# Annex A Replacement Pages of Revised Water Supply Impact Assessment

Issue No. : 5  
Issue Date : June 2024  
Project No. : 2127

## **WATER SUPPLY IMPACT ASSESSMENT**

### **APPLICATION FOR AMENDMENT OF PLAN UNDER SECTION 12A FOR THE TOWN PLANNING ORDINANCE (CAP. 131) FOR MIXED USE DEVELOPMENT AT LOTS 796 AND 1008RP IN D.D. 77 AND ADJOINING GOVERNMENT LAND IN PING CHE, TA KWU LING, NEW TERRITORIES**

## ***Figure 5.1***

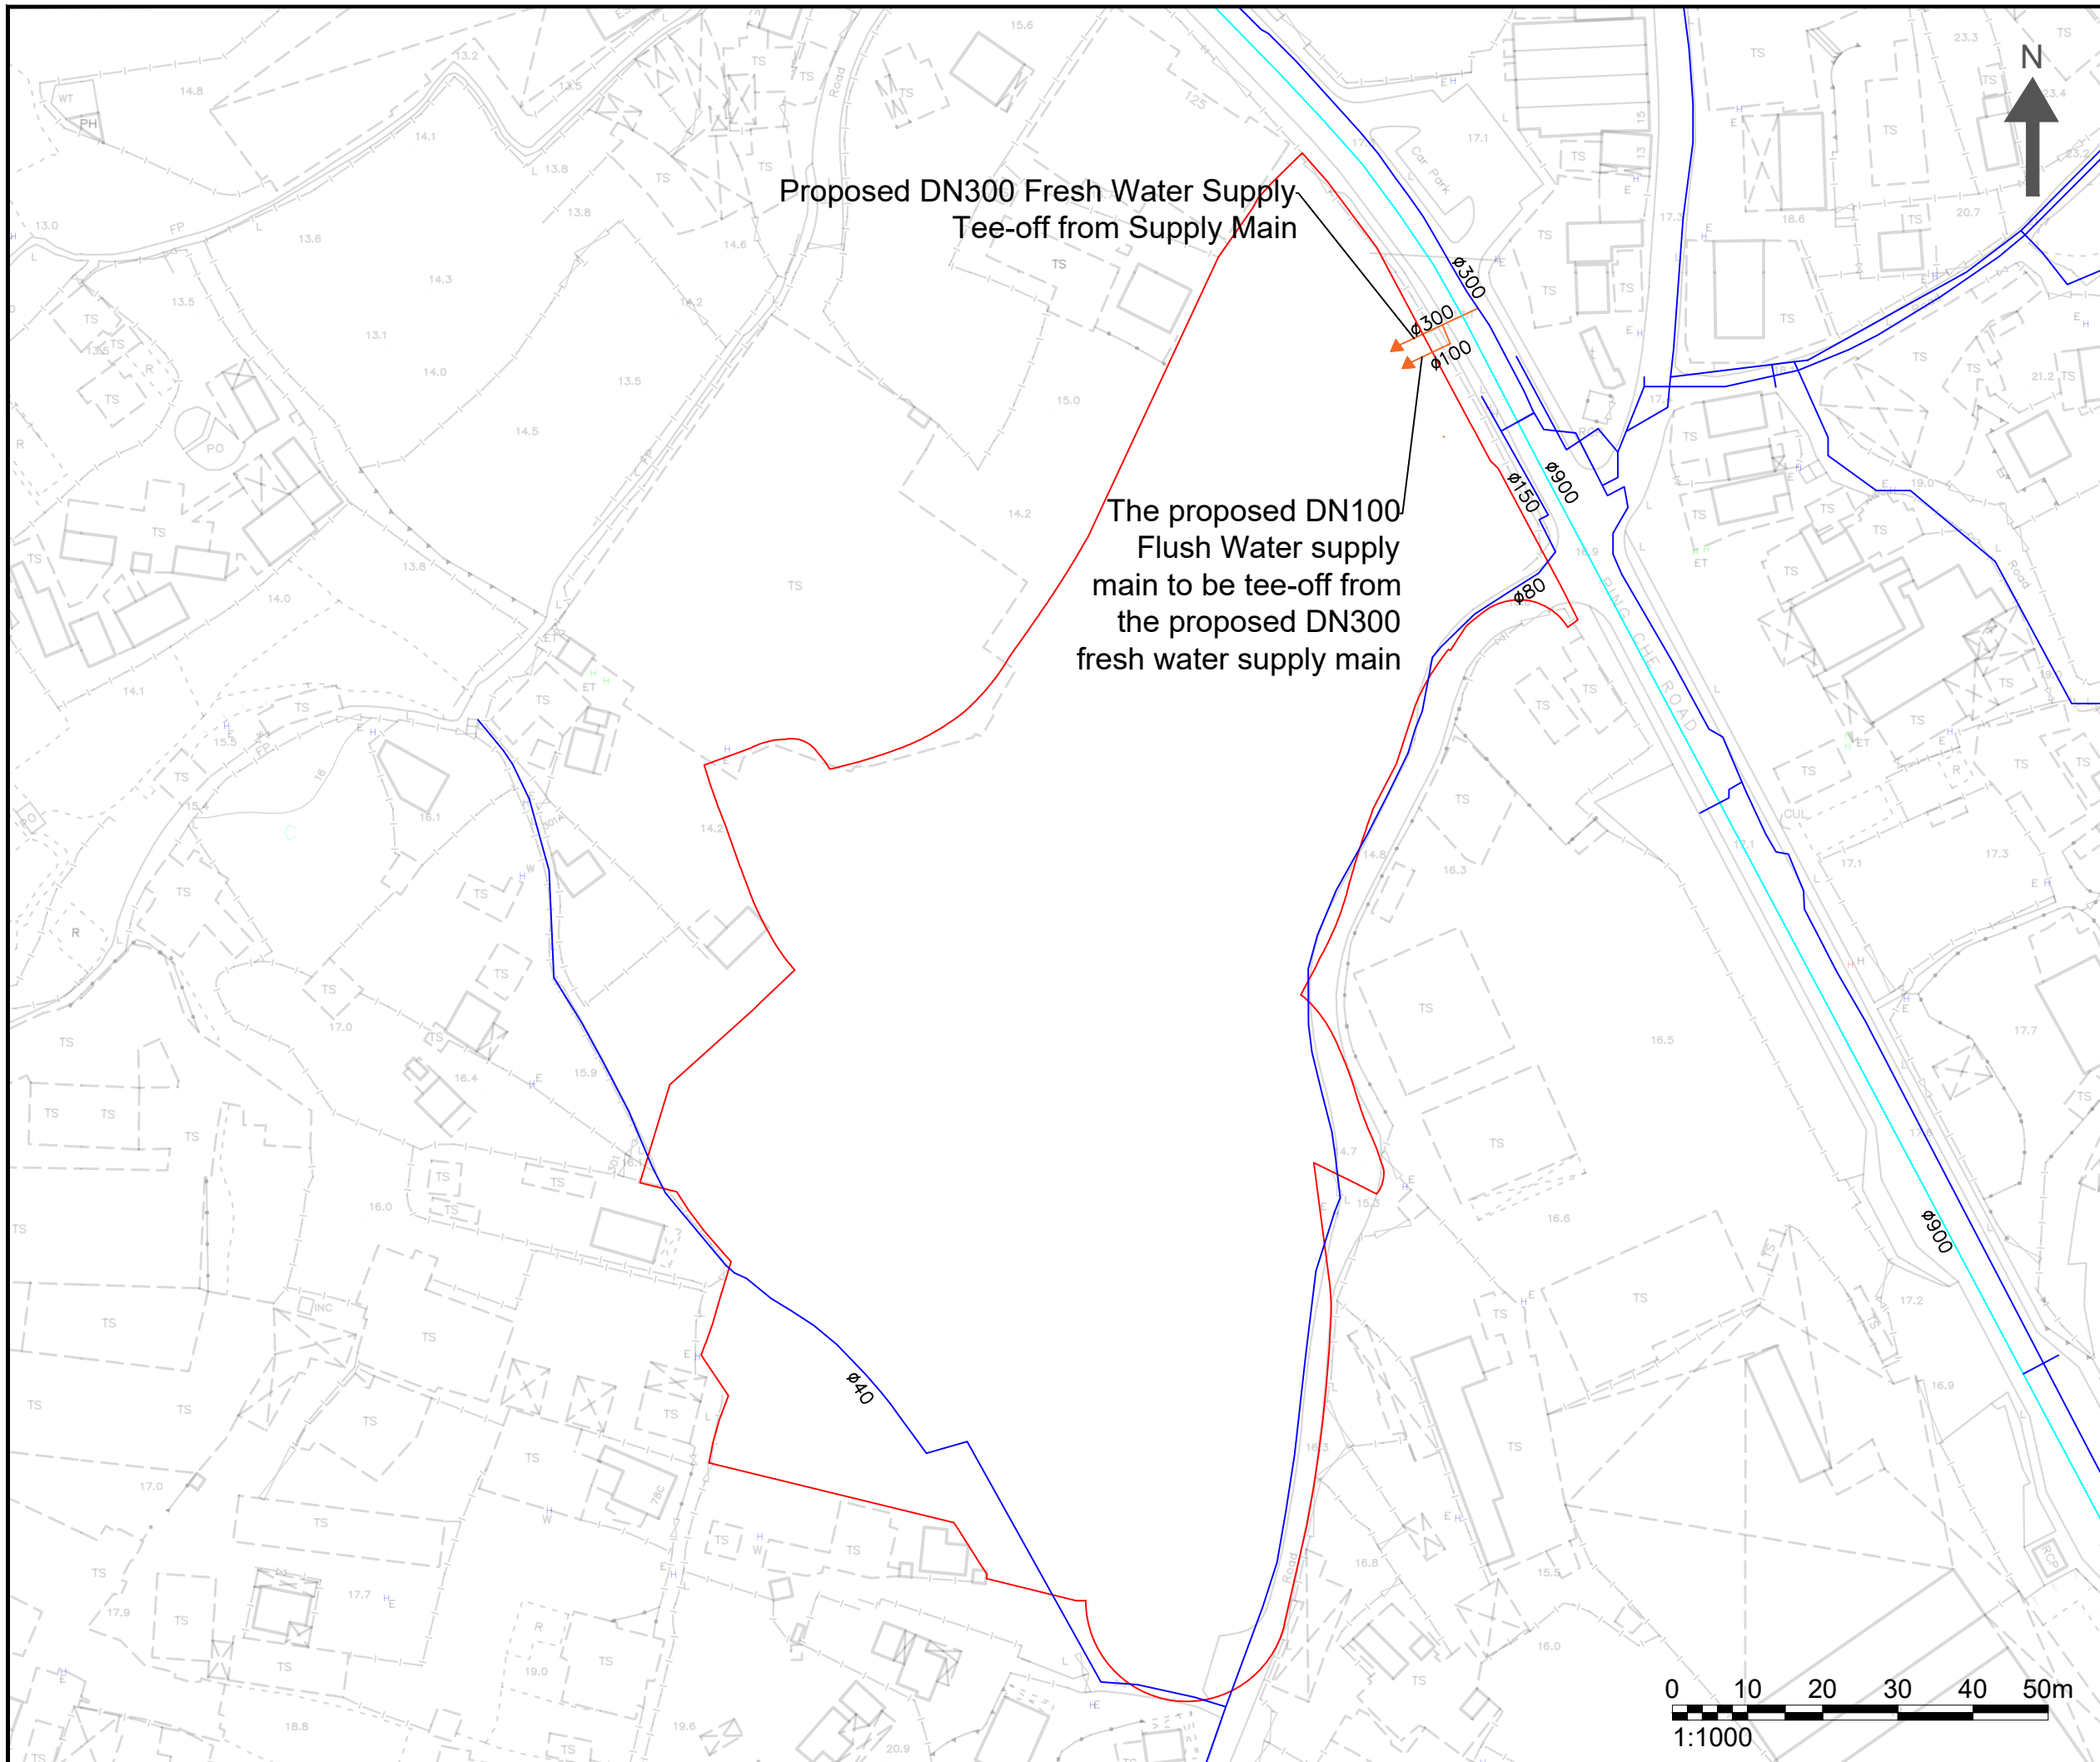
- 5.1.3. Based on the water demand of proposed development discussed in **Section 4** and **Appendix B**, a DN300 fresh water supply and a lead-in valve is proposed to be tee-off from existing DN300 fresh water main along Ping Che Road, and the proposed DN100 flush water supply main is proposed to be tee-off from the proposed DN300 fresh water supply main. The fresh water demand will be occupied approximately 42.9% of the proposed DN300 freshwater distribution main, and the flush water demand will be occupied approximately 78.7% of the proposed DN100 flush water distribution main. The detailed calculation is shown in **Appendix C**. It is recommended to construct the inlet at the northeast side of the Application Site which is tee-off from Ping Che Road located at northeast of the application site.

- 5.1.4. The proposed fresh water supply system within the site will be further developed in detailed design stage.
- 5.1.5. The indicative location of the proposed water supply main to be tee-off from public water supply system refer to **Figure 5.1**. Detailed water mains calculation can be referred to **Appendix C**.
